**Revision of Manuscript Number:** IEEE-TPWRS-01391-2021, version 1 February 19, 2022

**Journal:** IEEE Transactions on Power Systems

**Author:** Abhishek Halder, Kenneth F. Caluya, Pegah Ojaghi, Xinbo Geng

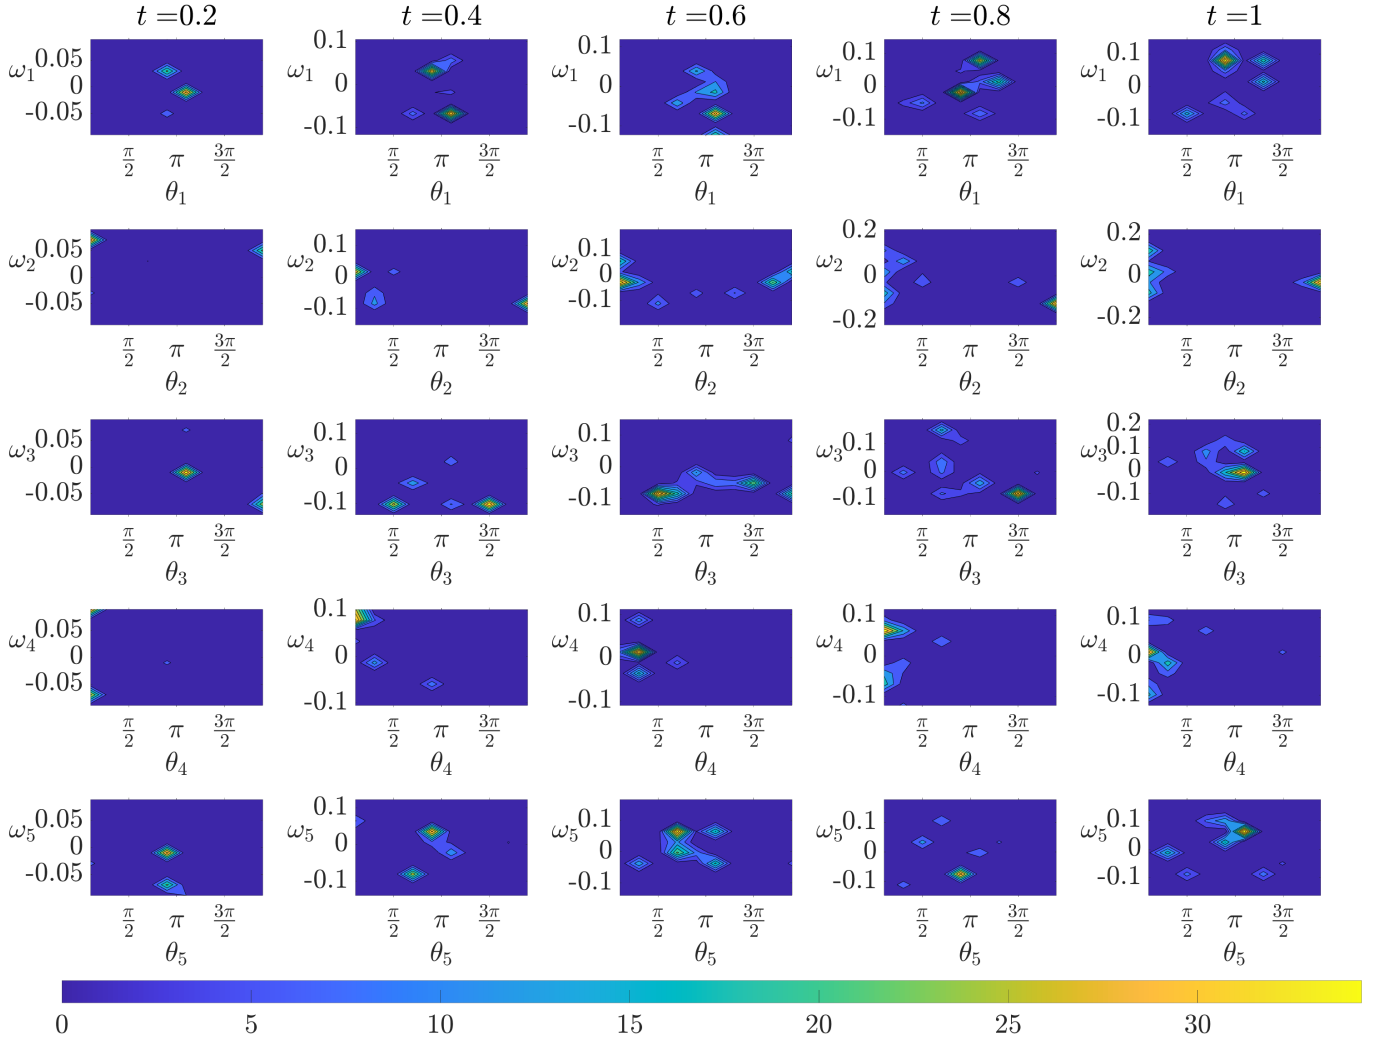
*Figures 5 and 6 are unreadable.*

**Response:** Thanks for this comment. In the previous version, the strict 10 page limit enforced small figure sizes. In the revised manuscript, Figures 5 and 6 are made larger. Also, the Fig. 6 in the revised manuscript shows the transient  $(\theta_i, \omega_i)$  bivariate marginals for all the five generators in Case II; the previous version showed the same only for the generator 4 (bus 6). We believe these changes have improved clarity.

Regarding the style of plots, we had considered plotting the bivariate marginals as planar contour plots (as in Fig. 1 in this rebuttal document) but decided against it because of the following two reasons.

*First, in our opinion, this kind of plot is scientifically misleading as they hide the fact that these bivariate marginal PDFs are not really supported on the plane, or the subsets thereof, but instead have cylindrical supports.* Our message that the proposed method explicitly accounts this manifold geometry in the computation, would be missed had we chosen to make the plots the other way.

*Second, the planar contour marginal plots require additional mental efforts from the readers to correctly parse the statistical information conveyed.* For instance, consider the fourth column, second row subplot in Fig. 1 in this rebuttal document. It is upon the reader to parse that the two high probability regions on the left and right of that subplot are actually referring to the same angular high probability region around  $\theta_2 = 0$  rad, thanks to the periodic boundary condition on the angular variable. Our philosophy of technical communication is that the onus is on the authors, not on the readers, to clarify the scientific information as correctly as possible. We thus prefer to make plots that depict the variables as they are.
